AMENDMENTS TO THE DRAWINGS

REMARKS/ARGUMENTS

In response to the Office Action mailed November 3, 2008, Applicant amends his application and requests continued examination. In this Amendment claim 7 is cancelled and no claims are added so that claims 1, 2, 4-6, 11, 12, and 14-25 are now pending.

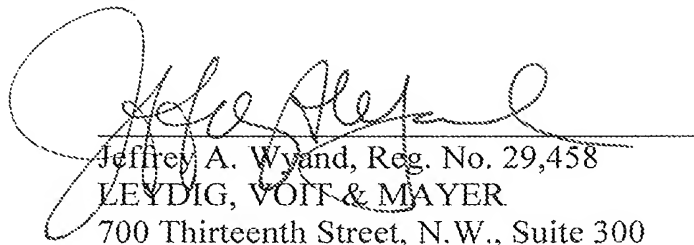
To the extent any of the grooves in the wire guiding elements of Bonito, McMurtrie, and Bradley have central axes, it is apparent that all of those central axes are perpendicular to the pivot axes of the first and second levers of the respective tools. In Bonito, that pivot axis is identified with reference number 10. In McMurtrie, the pivot axis is identified by reference number 11. Bradley identifies a pin 18 that provides that pivot axis. It is elementary, by inspecting the figures of the three references, that all of the depicted wire strippers include the common feature of the transverse orientation of the pivot axis with respect to what might be considered a groove axis, if one exists, with respect to the guiding grooves identified in the Office Action.

The combination of references only emphasizes the importance of the orthogonal relationship of the groove and pivot axes in wire stripping tools and suggests that one of skill in the art would not make a different arrangement, perhaps because of the unwieldiness of using a reoriented tool, as suggested in the previous Response.
